# CLASS I SERVICE INSTRUCTIONS

No. 1105  
ATA Code 36-10

**SUBJECT:** PNEUMATIC - INSTALLATION OF IMPROVED INSTRUMENT AIR LINES

**EFFECTIVITY:** BEEHCRAFT Duchess 76, serials ME-1 through ME-154.

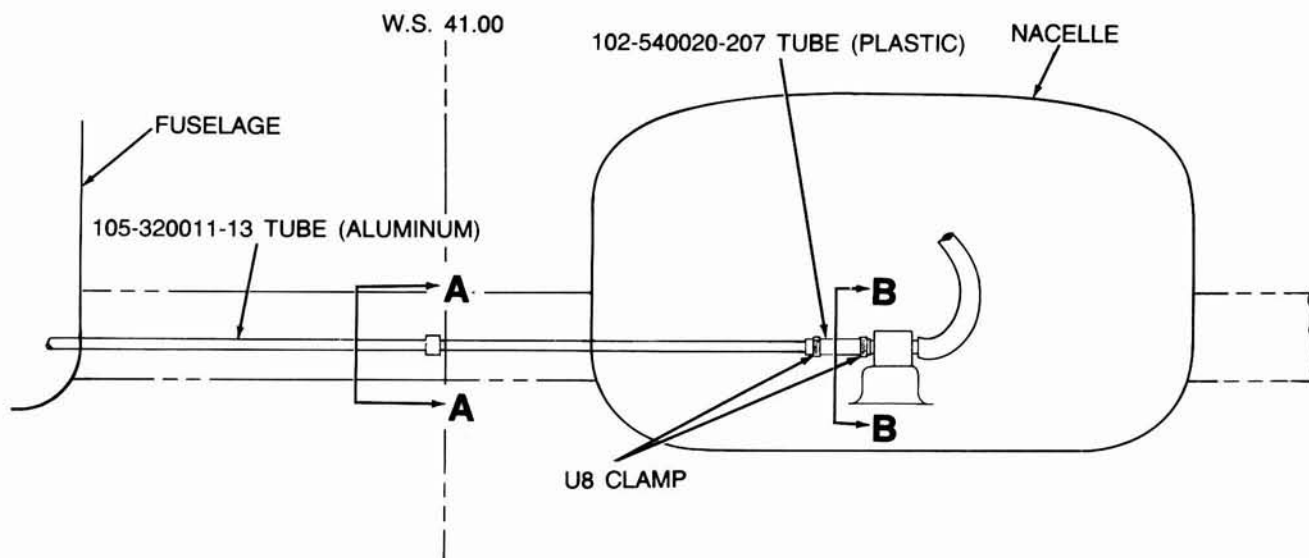
6. Place the new P/N 105-320011-13 aluminum tube in position as shown in the illustration. Connect the inboard end of the P/N 105-320011-13 aluminum tube to the plastic tube inside the fuselage using the clamp which was removed in step 5.

11. Connect the outboard end of the P/N 105-320011-13 aluminum tube to the pressure regulator using a P/N 102-540020-207 plastic tube and the hardware as shown in the illustration.

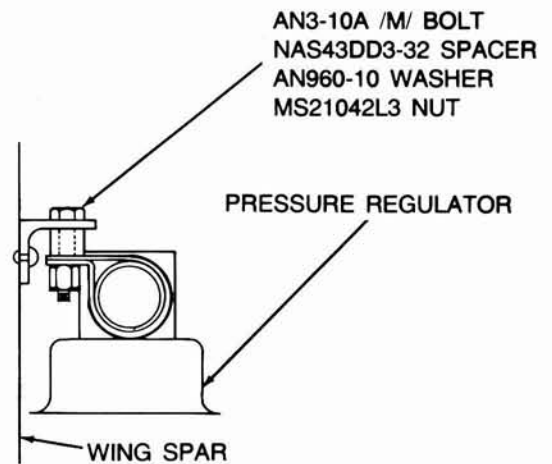
7. Locate the clamp which attaches the manifold pressure line to the front spar (W.S. 41.00) and remove the screw, nut and washer.
8. Install a P/N AN743-12 bracket and a P/N MS21104D10 clamp to hold the P/N 105-320011-13 aluminum tube. Locate the bracket and clamp using the hardware as shown in the illustration, view A-A.

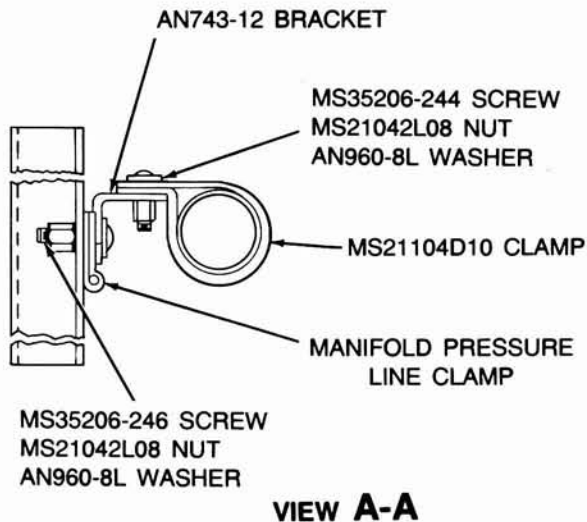
9. Remove the two bolts which attach the pressure regulator to the two brackets on the spar.
10. Reinstall the pressure regulator to the brackets using the spacers and other hardware as shown in the illustration, view B-B.
